PRODUCT CHANGE NOTIFICATION

Bourns® Model SRP4018FA, SRP4020FA, SRP4030FA, SRP5030CA, SRP5050FA, SRP6030CA, SRP6060FA and SRP7030CA Series Shielded Power Inductors

Change to Core Design and Solder Material

IC23121

Existing Inner Core Design	Revised Inner Core Design

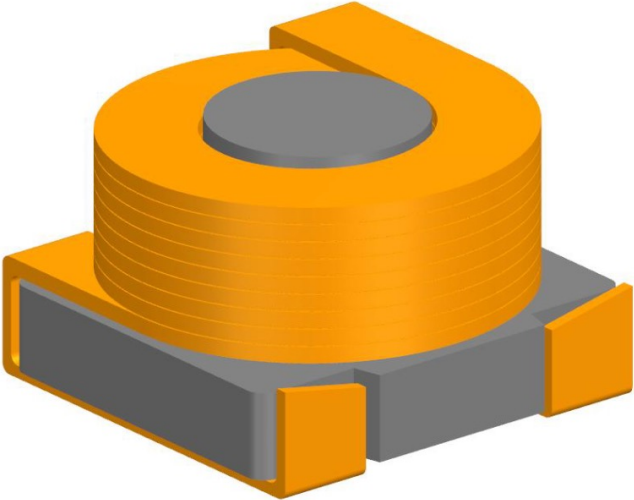
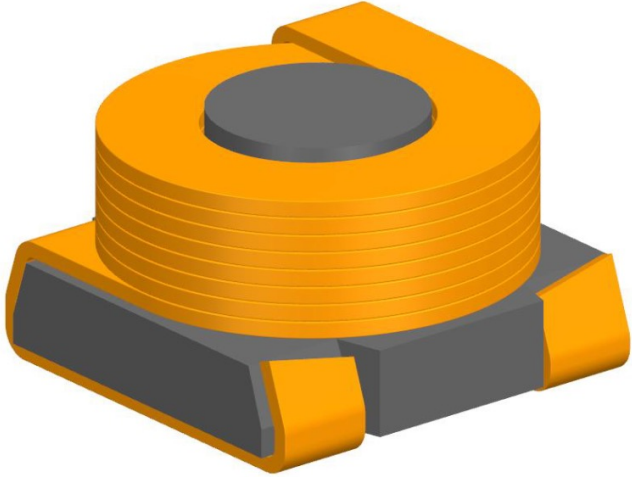
Riverside, California – November 10, 2023 – As part of our continuous improvement efforts, effective March 15, 2024, Bourns will change the inner core design and solder material for the Model [SRP4018FA](#), [SRP4020FA](#), [SRP4030FA](#), [SRP5030CA](#), [SRP5050FA](#), [SRP6030CA](#), [SRP6060FA](#), and [SRP7030CA](#) Series Shielded Power Inductors. The modified inner core will have a sloping bottom design to improve molding durability and the solder material will now be entirely made of tin instead of tin and copper. A list of affected part numbers is included below.

Existing Solder Material	Revised Solder Material
Sn + Cu	Sn

The use of the new inner core bottom design and solder material will not change the specifications for the affected Shielded Power Inductors. The form, fit, and function of the affected inductors will remain the same. The quality and reliability of the affected inductors should be improved as a result of the design change. Traceability will be maintained through lot code and date code.
